RE: Revised Two Rivers Slope Analysis
Technical Adequacy Review
DRMS Letter Date June 1, 2022

TECHNICAL ADEQUACY REVIEW LETTER

Date: June 1, 2022
To: Rob Zuber
CC: Jason Musick, Michael Cunningham
From: Zach Trujillo
RE: Two Rivers Application, DRMS File No. M-2022-013
Technical Adequacy Review

SEISMIC STABILITY MODEL OUTPUTS

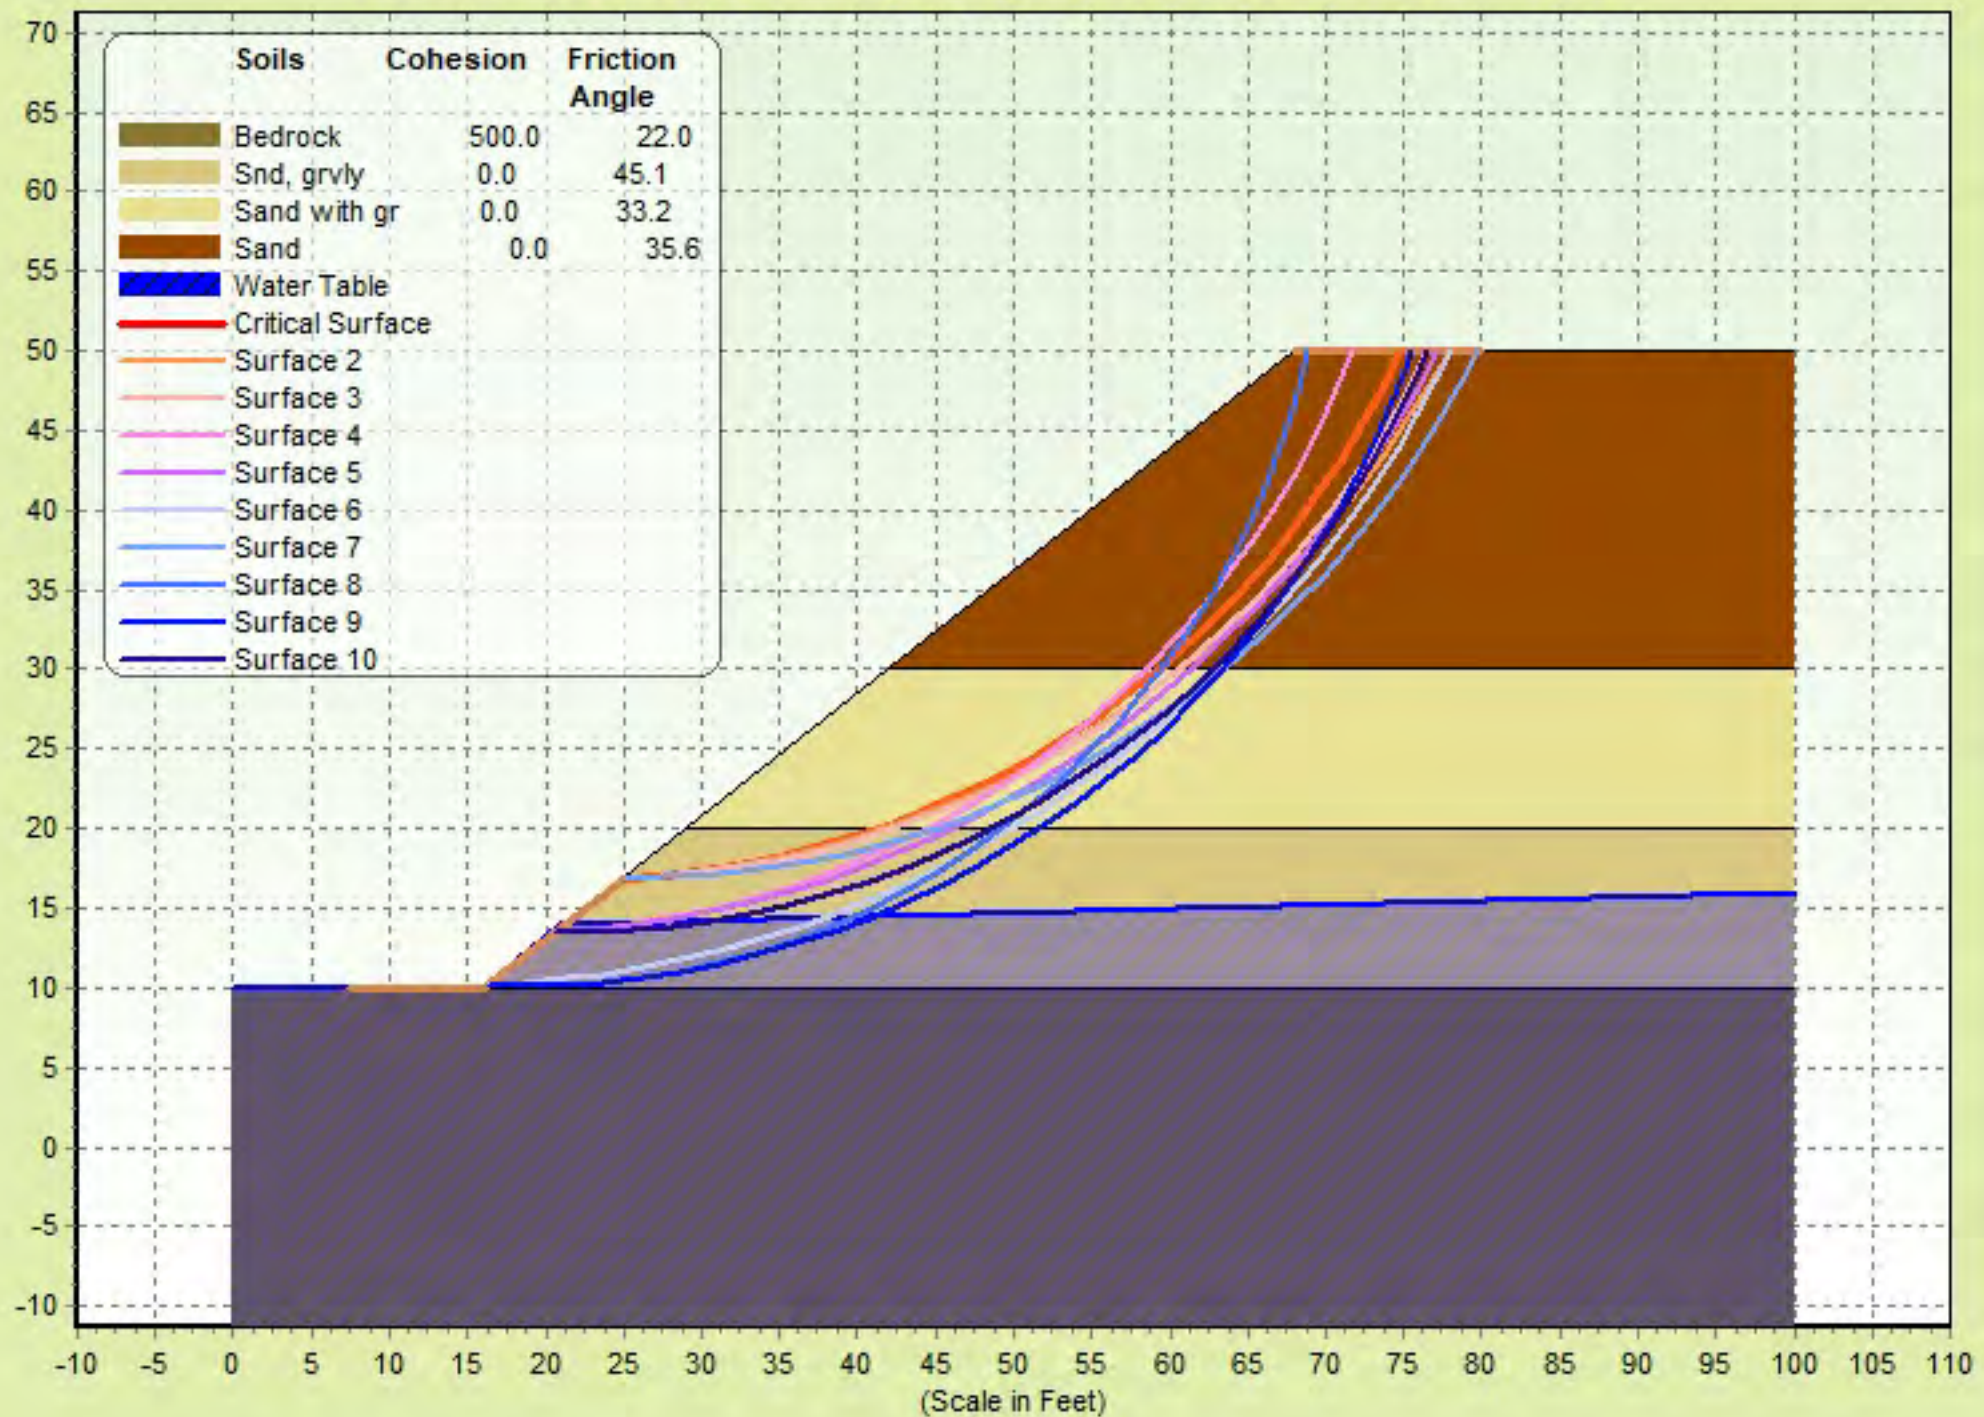
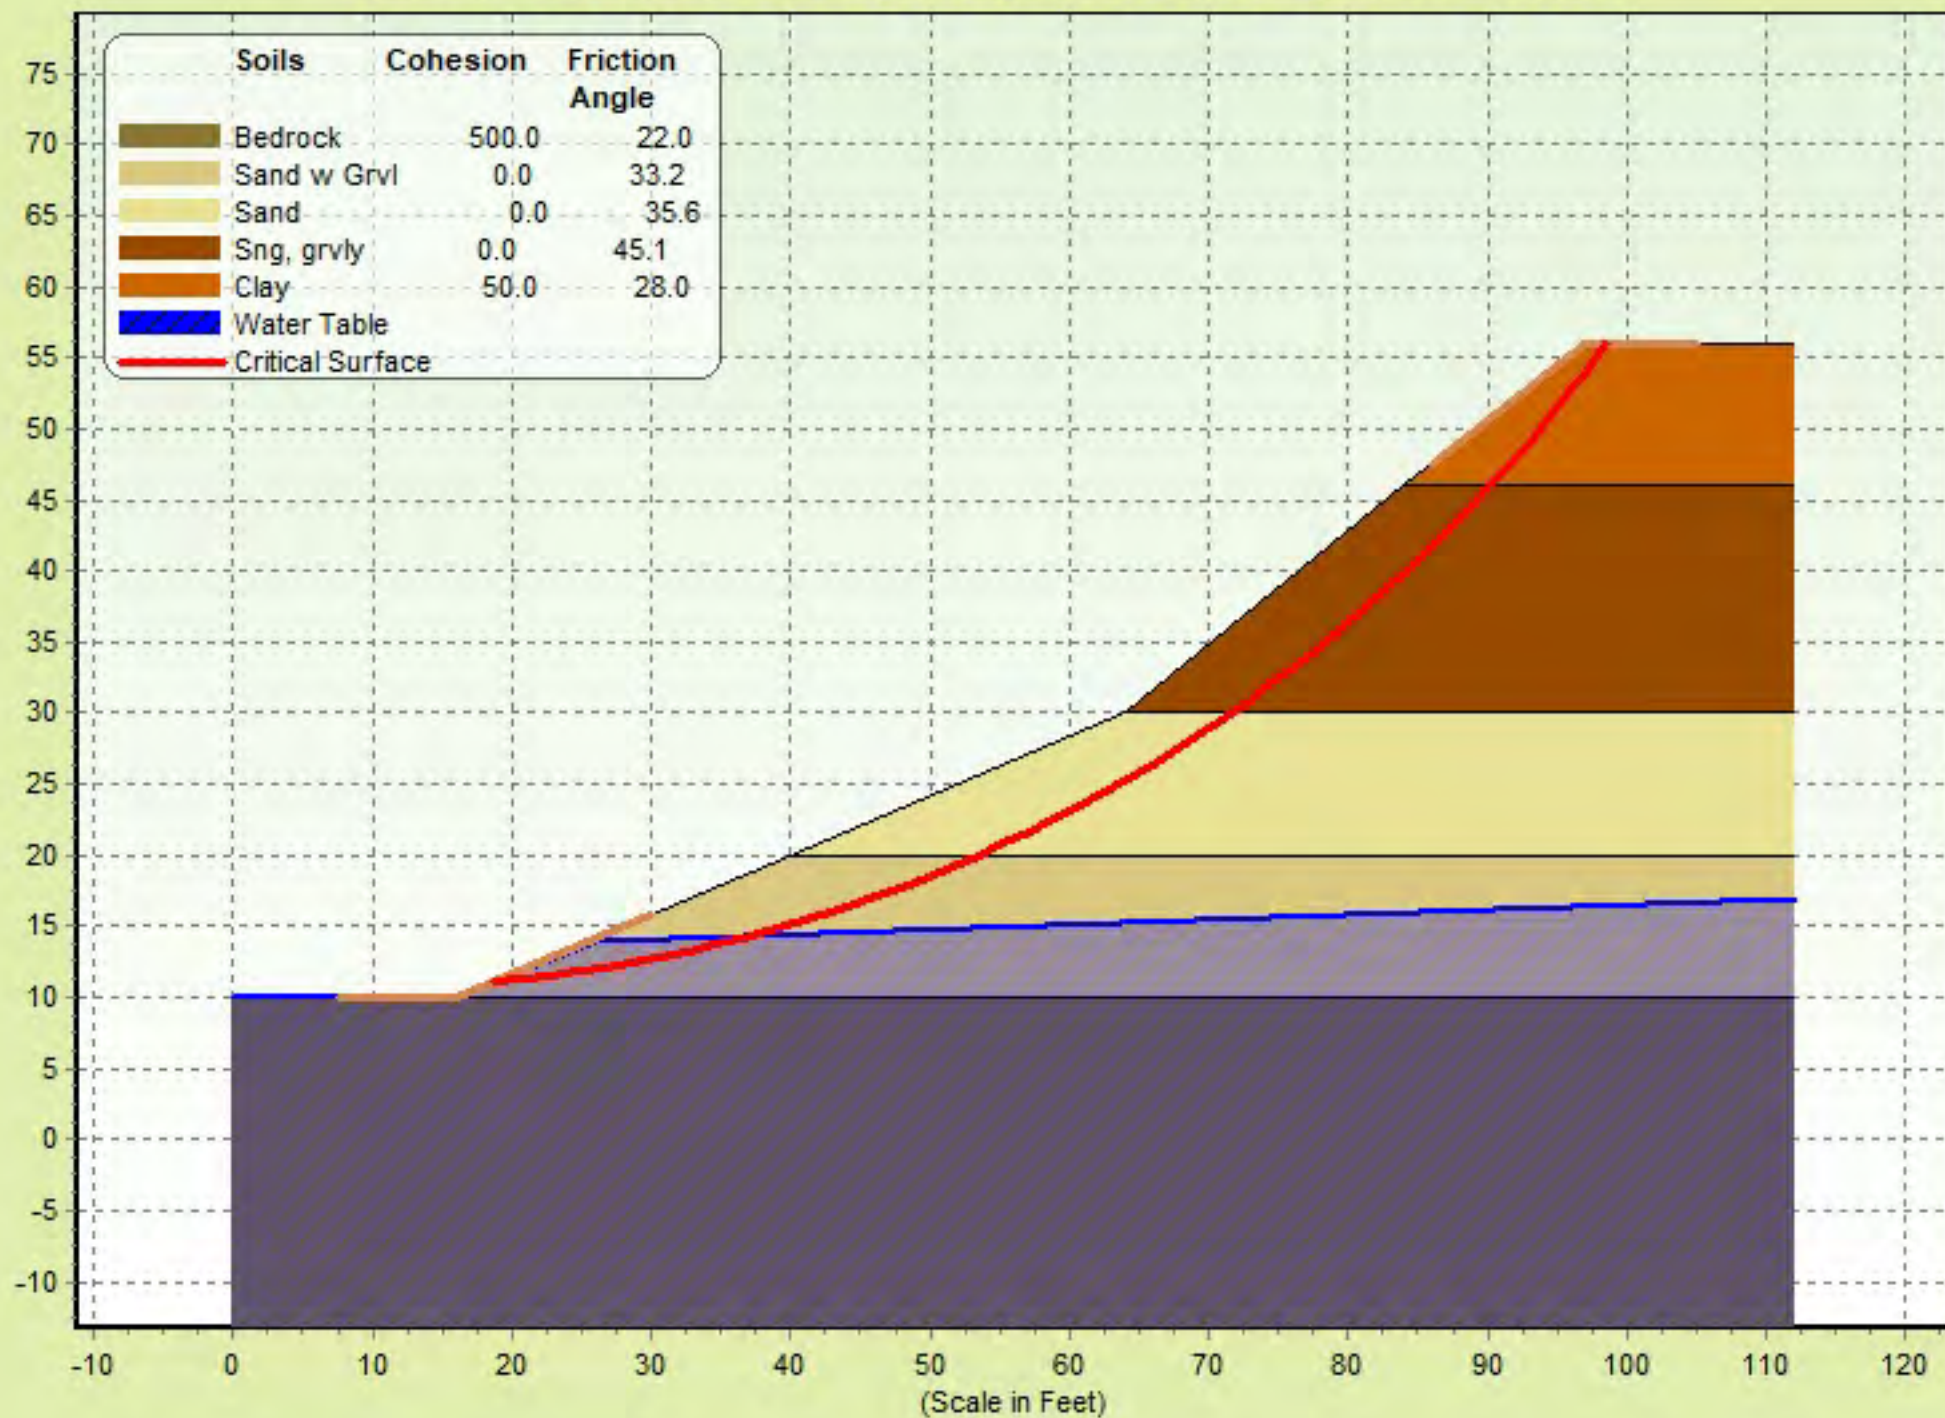
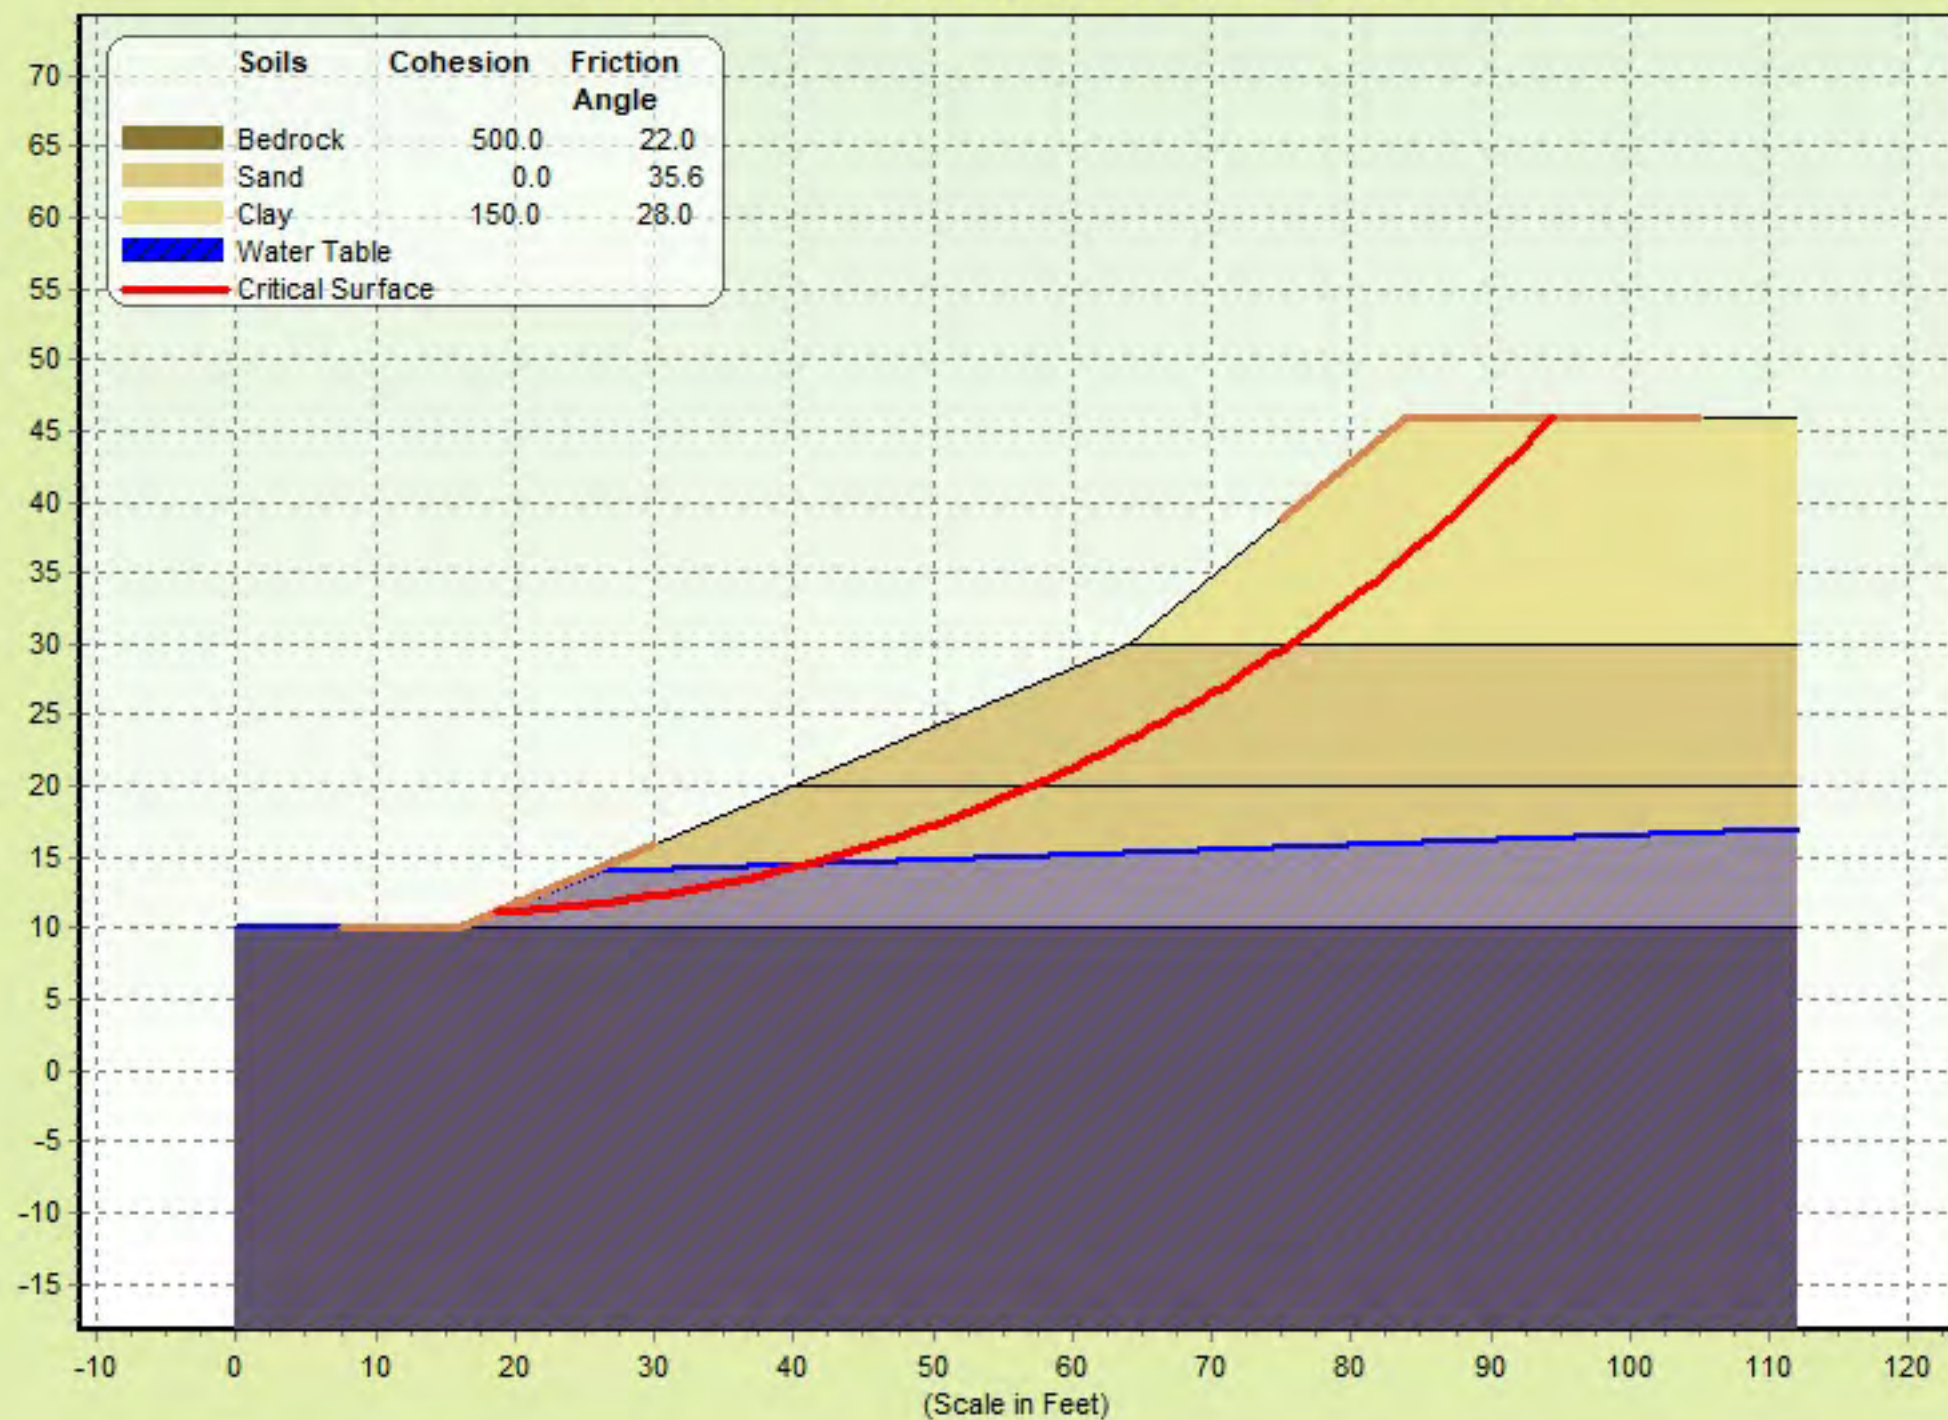
3. **Comment 3 – Please provide slope stability analyses for the four highwall scenarios under seismic conditions including rational for the seismic coefficient used in the analyses.** The four slope configurations were ran using a uniform horizontal and vertical acceleration factor of 0.075. This factor was chosen based on the United States Seismic Zone Map, which was based on the Uniform Building Code seismic values. Predicted safety factors varied between 1.15 and 1.26. Model outputs are presented in Attachment C. Included in Attachment C is the United States Seismic Zone Map.

Based on the information in the Report provided by Snake River and Table 1 of Section 30.4, FoS will be compared to strength measurements resulting from multiple tests for a critical structure. For static conditions, minimum required factor of safety is 1.3 and for seismic conditions, minimum required factor of safety is 1.15. As noted earlier under section Rule 6.5 of this memo, each resulting FoS from the four analyses indicate slope stability under static conditions. However, additional discussion will be need to be provided which will be outlined under the Comments at the end of this memo. In addition, the four scenarios provided in the Report were only analyzed on under static conditions and no models were ran or provided under seismic conditions as required under Section 30.
